Staff Report

To: Salt Lake City Planning Commission
From: Casey Stewart; 801-535-6260
Date: February 4, 2016
Re: PLNSUB2015-00958 Townes at 7th Street Planned Development

PLANNED DEVELOPMENT

PROPERTY ADDRESS: 323 and 325 South 700 East
PARCEL ID: 16-05-302-001 and -002
MASTER PLAN: Central Community
ZONING DISTRICT: RMF-45 (Residential Multi-family)

ATTACHMENT B: Site Plan

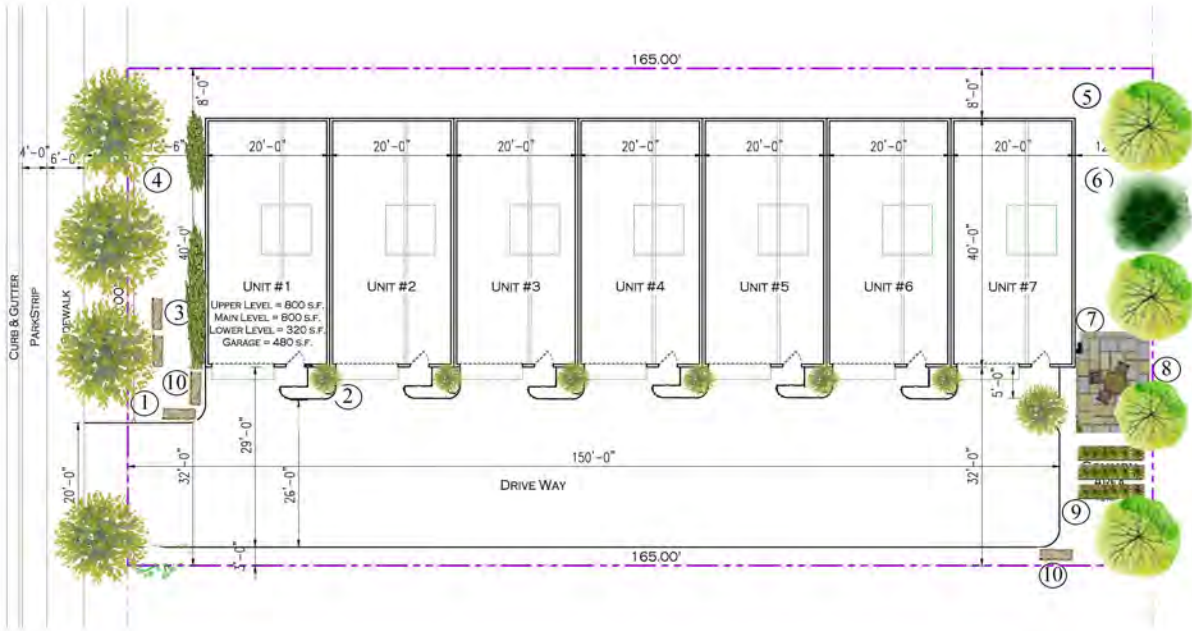
The RMF-45 zone requires a 30-foot rear yard setback. The proposal seeks to reduce that requirement down to 12 feet to allow for more building coverage in order to achieve the proposed seven units. Considered by itself, the reduced rear yard setback modification is problematic on three points: the amount of modification is significant, the amount of open yard areas for the building occupants to utilize is significantly reduced, and the anticipated open buffer between this building and the residential property behind (east) this site will be reduced.

Attached is the landscaping and common amenities site plan. You will see that we plan on including plenty of trees along that east side to create some form of buffer to that backyard neighbor. We are also including a high amount of frontyard trees and shrubbery. Although we had to minimize their size, we will be able to keep those small planter box areas near the entrance of each door.

As far as amenities go, we plan on including common gathering seating/benches, outdoor communal patio area including BBQ, communal gardening planter boxes, pet area, ornamental flower boxes, etc. We understand that none of these amenities alone is very impressive, but when we look at all of the common amenities combined with the more-than-adequate landscaping buffers, we feel this project goes above and beyond what would otherwise be expected. You will also notice that we are planning on salvaging that pear tree along the east fence line.
